Mixed-Use Development
2 Mark Street & 1-3 Marsden Street, Lidcombe NSW 2141

Development Application

to approved DA 2022 / 0253

DA - B	DRAWINGS UPDATED IN RESPONSE TO DEAP MEETING & COUNCIL RFI (June 2025)	19/08/2025	YT	AHM
DA - A	ISSUED FOR DEVELOPMENT APPLICATION	17/02/2025	YT	AHM
DA - P.3	ISSUED FOR DEAP MEETING	18/06/2024	YT	AHM
ISSUE	AMENDMENT	DATE	DRAWN	CHECKED
Drawing is NOT VALID or issued for use, unless checked.

SHEET TITLE:
North Elevation - David Place

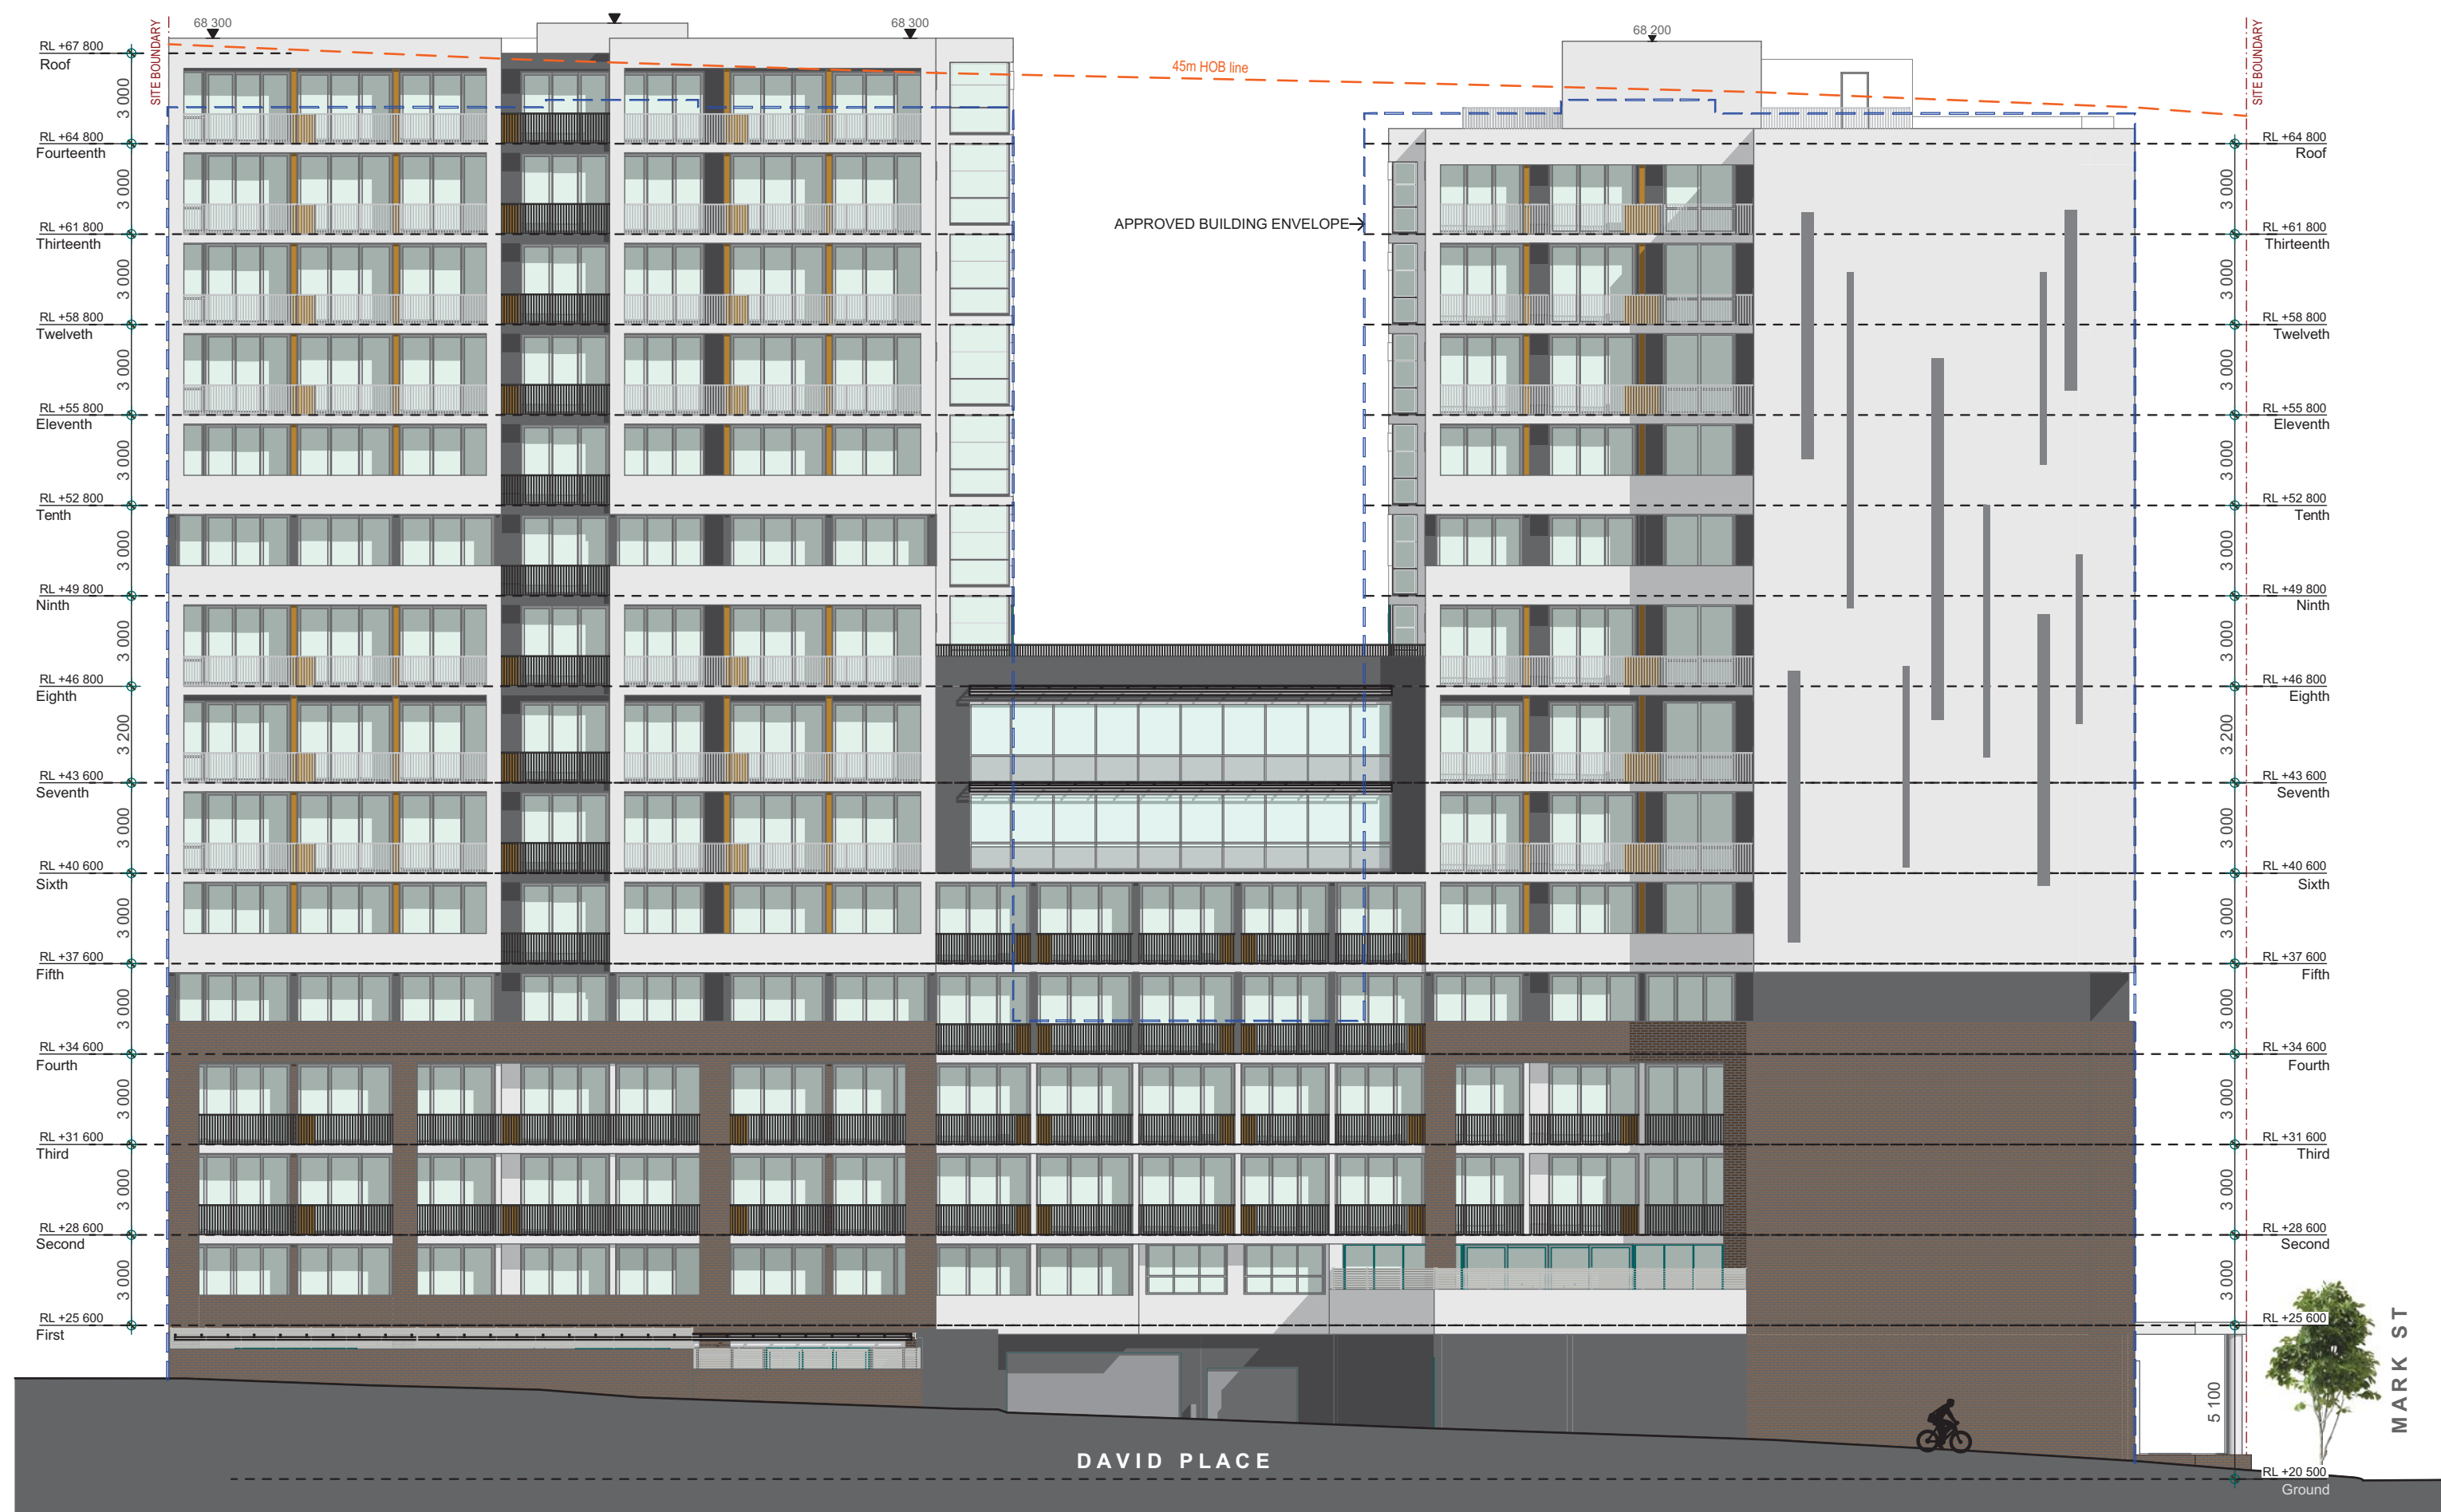
- Level 14 residential component at western tower deleted. Infill/add one floor to middle section of building
- New rooftop terrace on Level 8
- Floor to floor height to GF & Level 7 increased, floor RL's updated
- Facades updated. New materials introduced as shown clouded

SHEET TITLE:
West Elevation - Mark St

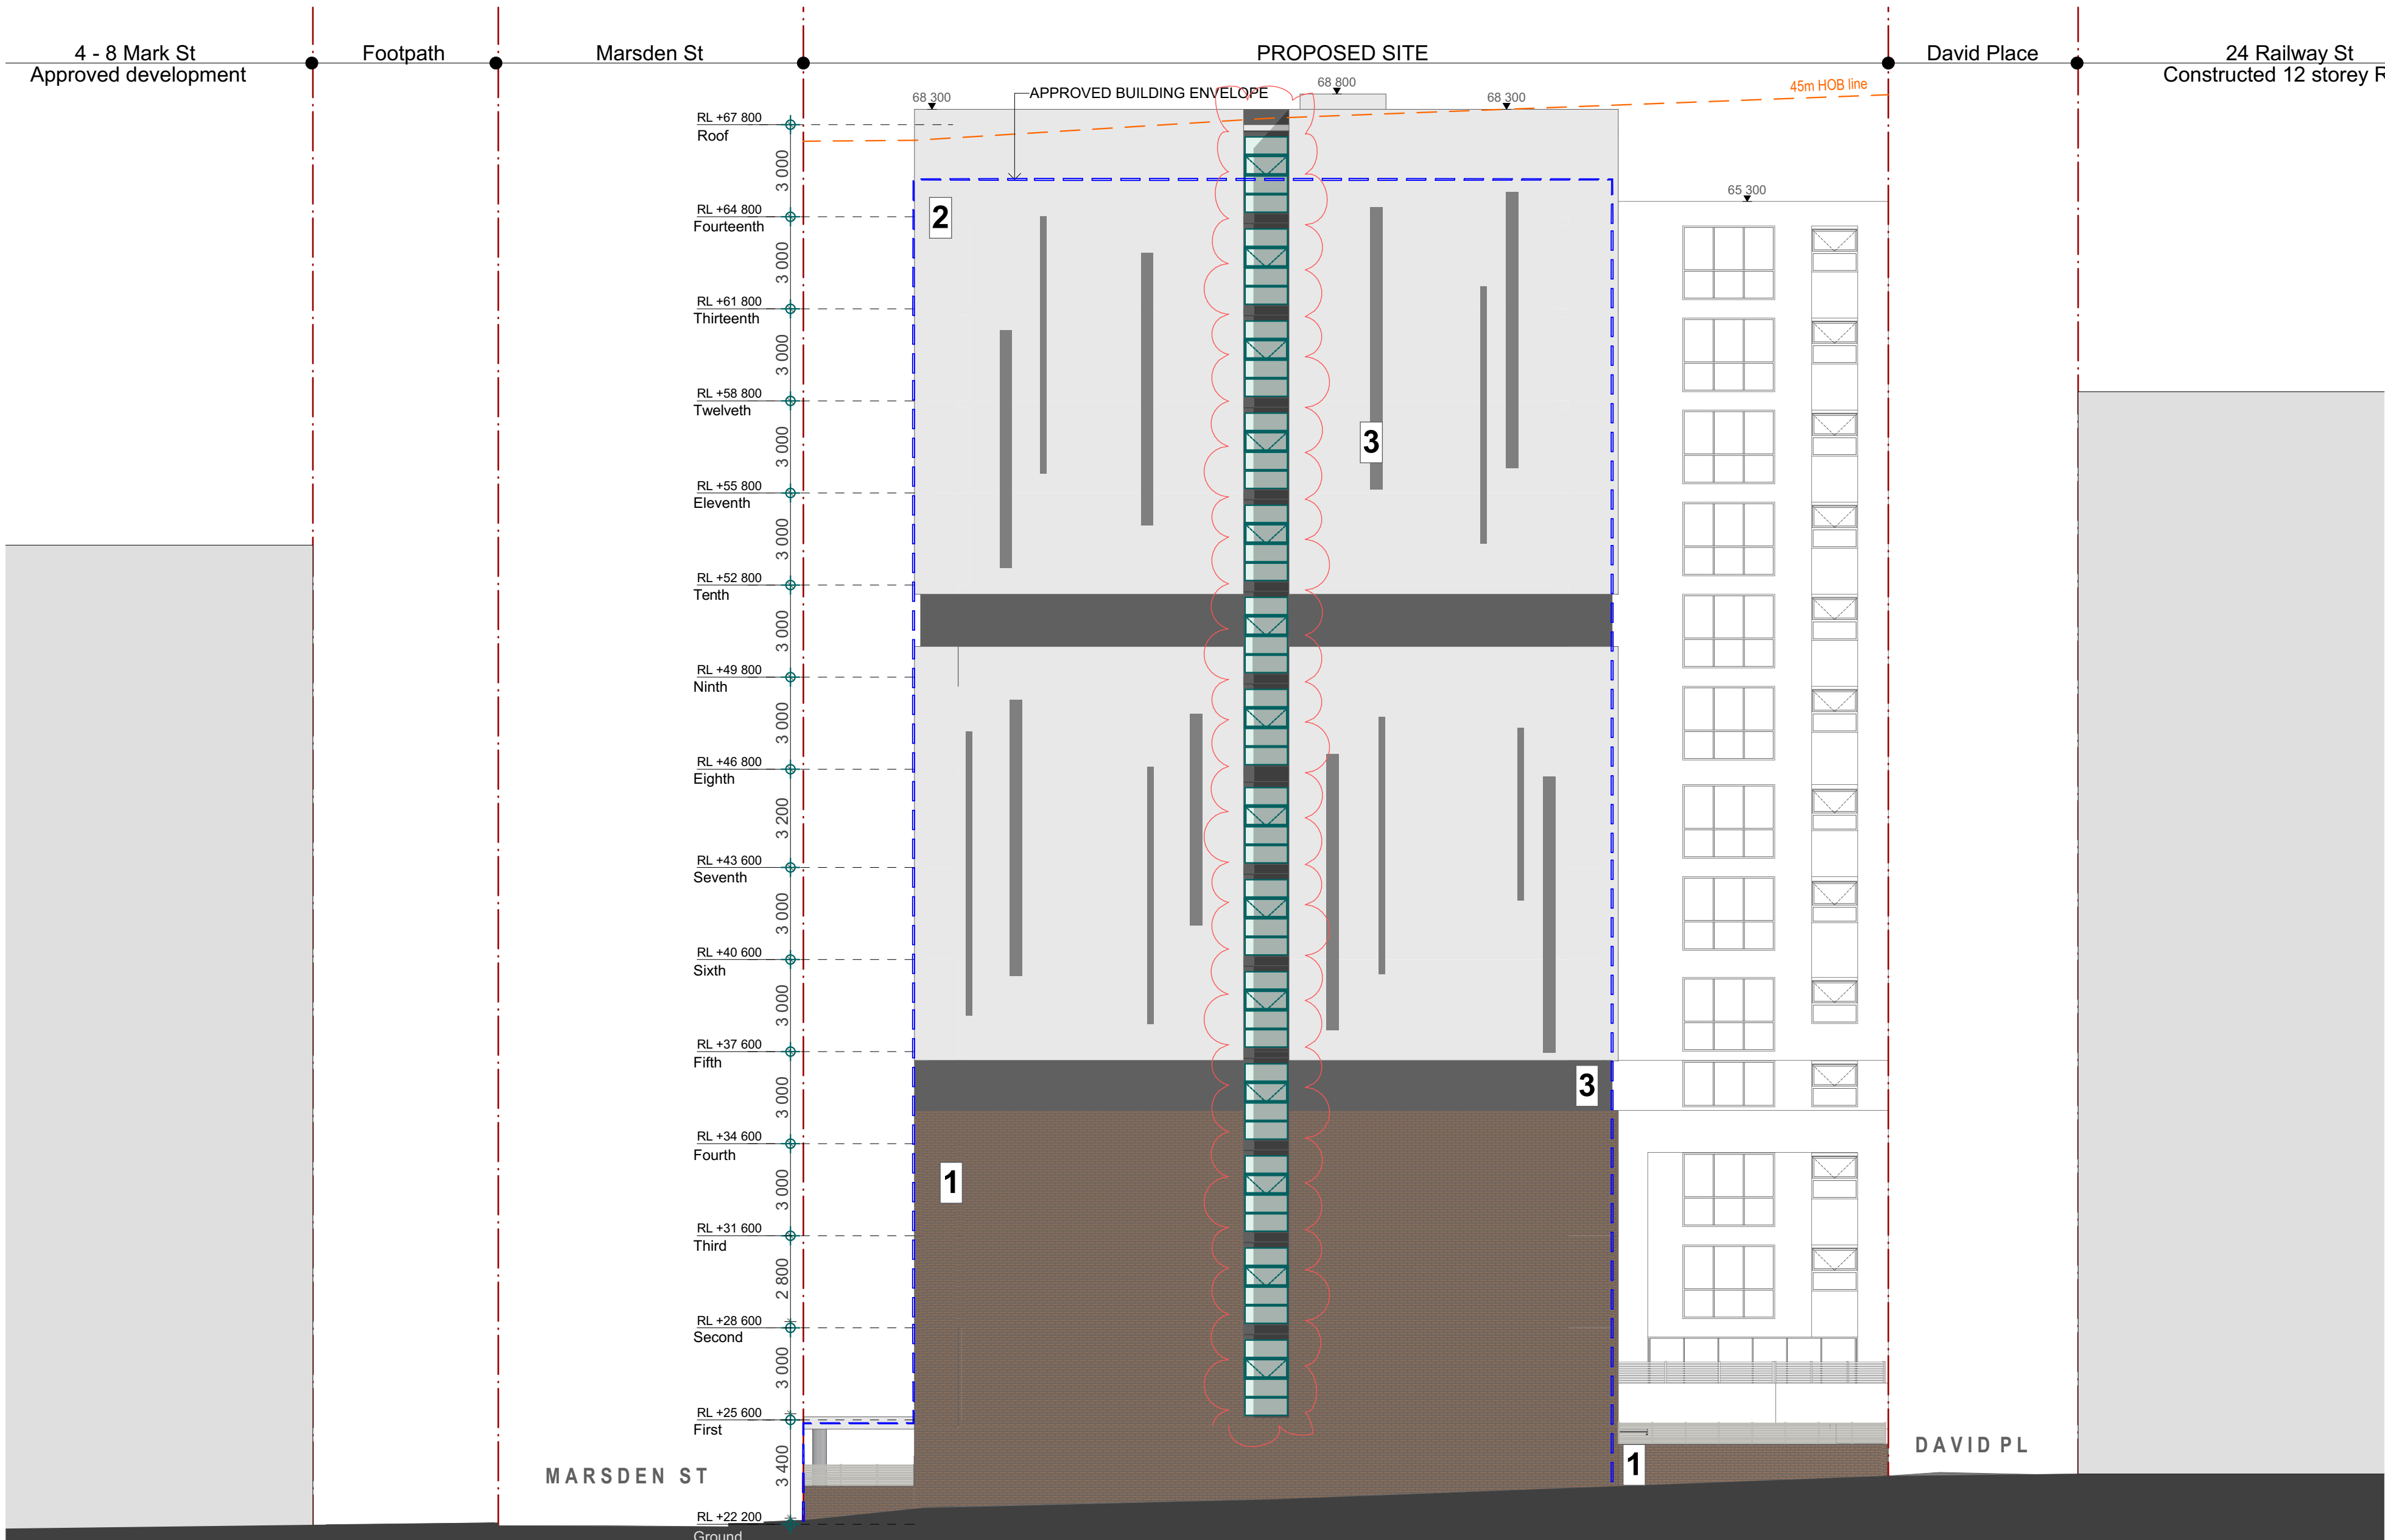
- Level 14 residential component at western tower deleted. Infill/add one floor to middle section of building
- New rooftop terrace on Level 8
- Floor to floor height to GF & Level 7 increased, floor RL's updated
- Facades updated. New materials introduced as shown clouded

SHEET TITLE:
East Elevation

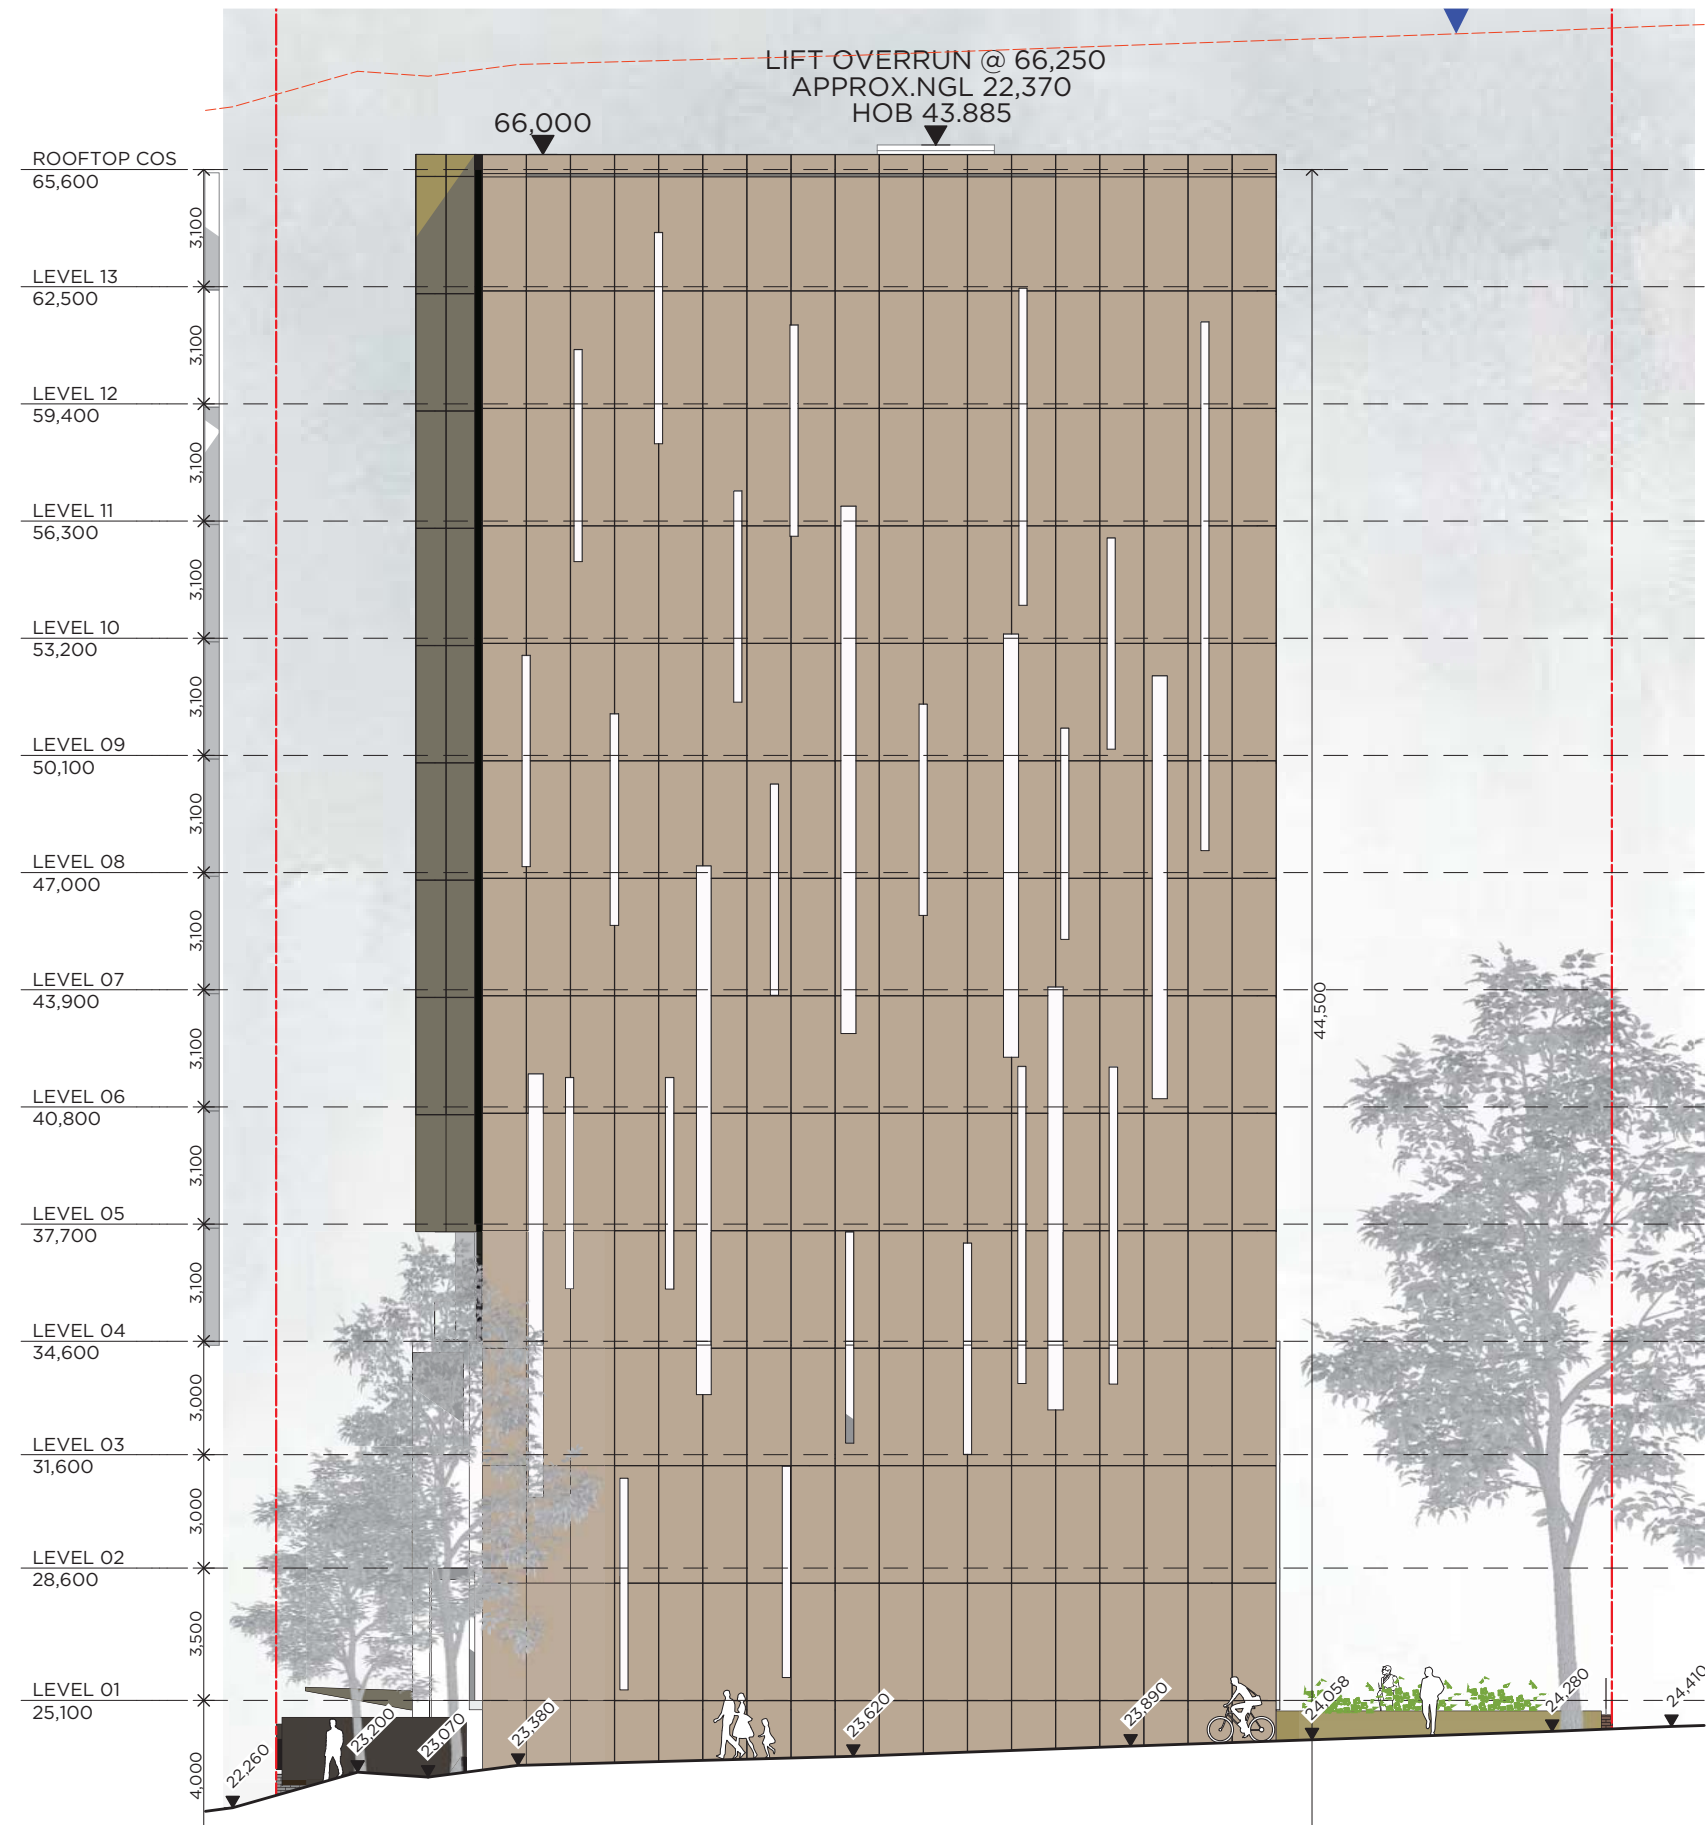
- Recess/indentation added to middle part of eastern facade for natural lighting & passive surveillance to nearby park
- Floor to floor height to GF & Level 7 increased, floor RL's updated
- Facades updated. New materials introduced as shown clouded
